Re: Seminole Electric Cooperative, Inc.
Seminole Generating Station, Putnam County Florida
Power Plant Certification No. PA 78-10
Post-Certification Amendment

Pursuant to Section 403.5113(1)(a), Florida Statutes and Rule 62-17.205, Florida Administrative Code, please accept this letter and attachments as a post-certification amendment to the Seminole Electric Cooperative, Inc. ("Seminole") Site Certification Application ("Application") for the Seminole Generating Station in Putnam County, Florida. This post-certification amendment addresses the extension of an asphalt road associated with the coal pile.

FIGURE XX.
BASIN 6

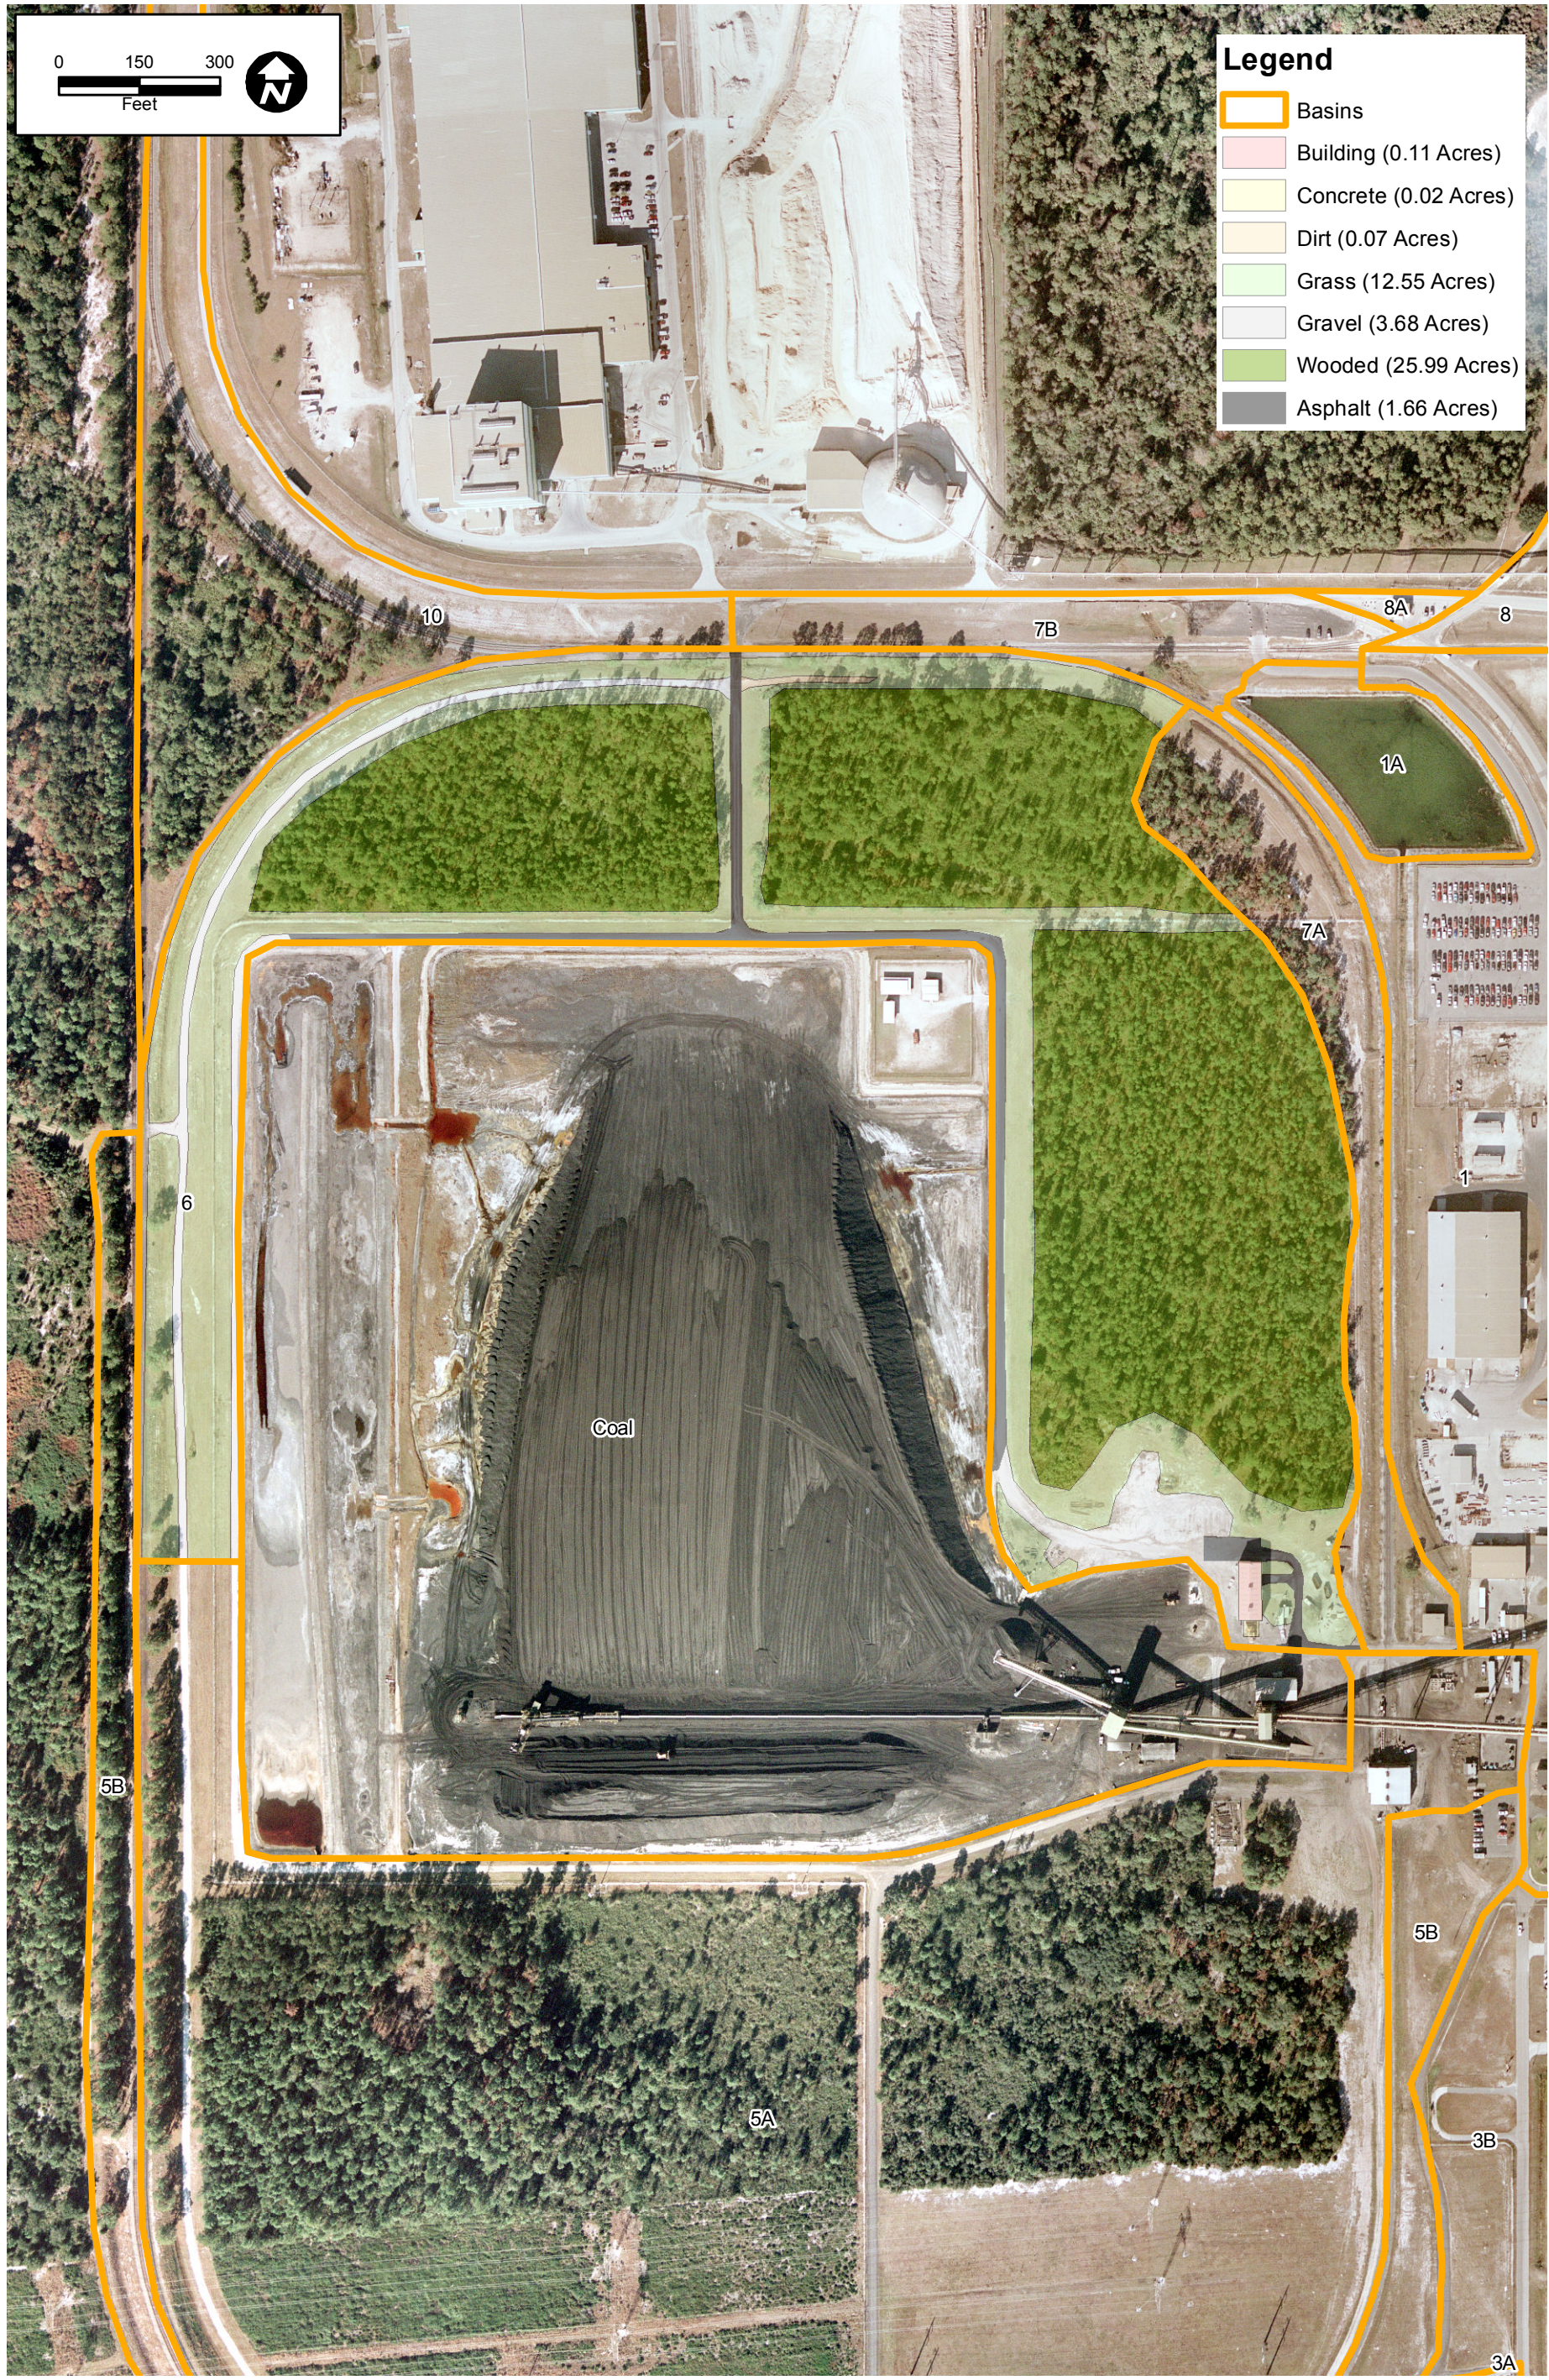
Seminole is requesting to pave three separate portions of an existing asphalt road that sits on the north-east corner of the coal pile. Area #1 will extend the existing road approximately 200 ft. to the south. The road will be approximately 20 ft. wide for a total area of approximately 4,000 sq. ft. Area #2 is an entryway to the hazardous waste storage area. The entryway is approximately 45 ft. x 15 ft. for a total area of 675 sq. ft. Area #3 is a service ramp into the coal yard, approximately 26 ft. x 10 ft. for a total area of 260 sq. ft. The combined area for all proposed paving is approximately 4,935 sq. ft. An aerial designating the approximate location of each area is included as Attachment A.

The existing surface for all of these areas is limerock with a compacted base. This material is similar in imperviousness to asphalt and Seminole does not expect the change to asphalt to increase significantly the runoff from these areas. Any additional runoff that may be generated will drain into an adjacent wooded upland area to the north and east of the coal pile. Runoff from the wooded area enters stormwater conveyance ditches and is directed to NPDES MSGP stormwater sampling point #7 prior to entering an on-site wetland. A map of the drainage basin that shows existing land cover is included as Attachment B.
